Illustrated Parts List - IPL Update

61

Removal of Plug 503 27 90-04.
Reason: The plug does not fill any function anymore.

1. Crankcase

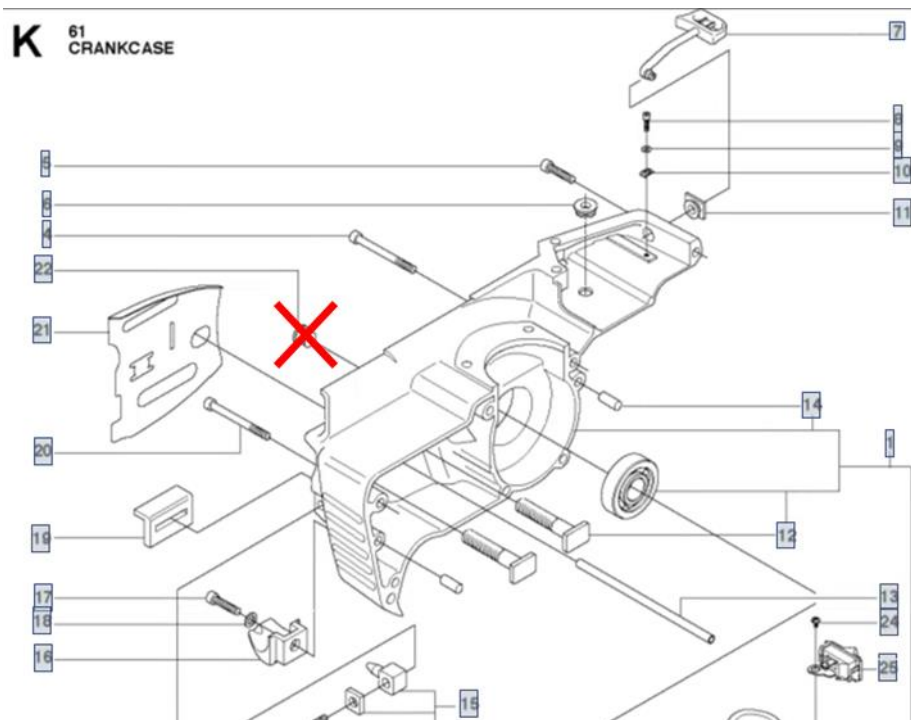
Remove plug 503 27 90-04 (pos. 22).
